# CITY OF PORTLAND BUILDING PERMIT

Job ID: 2011-10-2520-NEWCOM

<b>Project Name:</b>	144 Hutchins Drive; Maintenance Facility	<b>Project ID:</b>	2011-286
<b>Address:</b>	144 Hutchins Drive	<b>CBL:</b>	240- A-004-001
<b>Applicant:</b>	Phoenix Property Services		
<b>Planner:</b>	Shukria Wiar

**RE: Hutchins Drive Maintenance Facility  
Hutchins Drive, Portland, ME  
Response to comments**

**SITE PLAN**  
144 HUTCHINS DRIVE  
HUTCHINS DRIVE, PORTLAND, MAINE

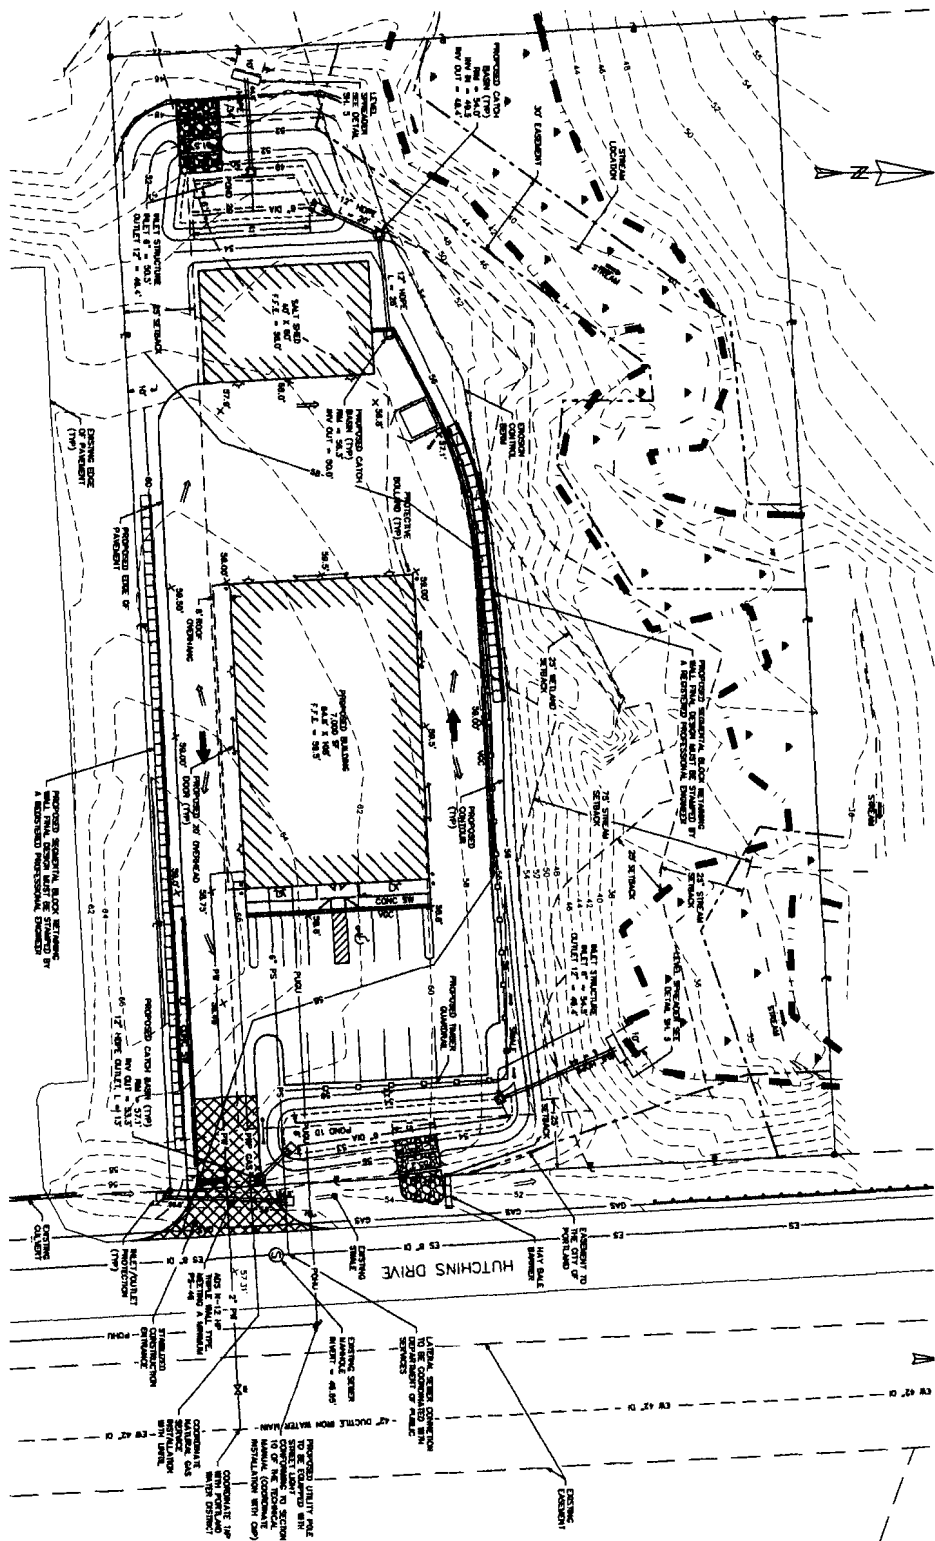
3. The zoning assessment on the site plan states that the maximum front yard is 25'. There is not a maximum front yard setback. There is a minimum setback based on the height of the building. The building must be set back one foot for each one foot of building height. The elevation plans were not submitted; please submit elevations so that it can be determined if the front setback is being met.

5. Parking spaces and aisles shall meet applicable dimensional standards as detailed in Section 1 of the Technical Manual.  
*All parking space and aisle dimensions have been provided on the Site Plan, Sheet 1.*

7. The applicant will need to submit for a sign permit (a separate permit) for the proposed project sign.  
*Sheet 1, General Note 9 has been revised to reflect this requirement.*

*Building elevations have been provided and the front yard setback has been revised to show a 20' front yard setback on Sheet 1.*

*Floor plan has been provided along with the building elevations, building footprint is 7,000 SF. Parking requirements have been addressed in General Note 6.*
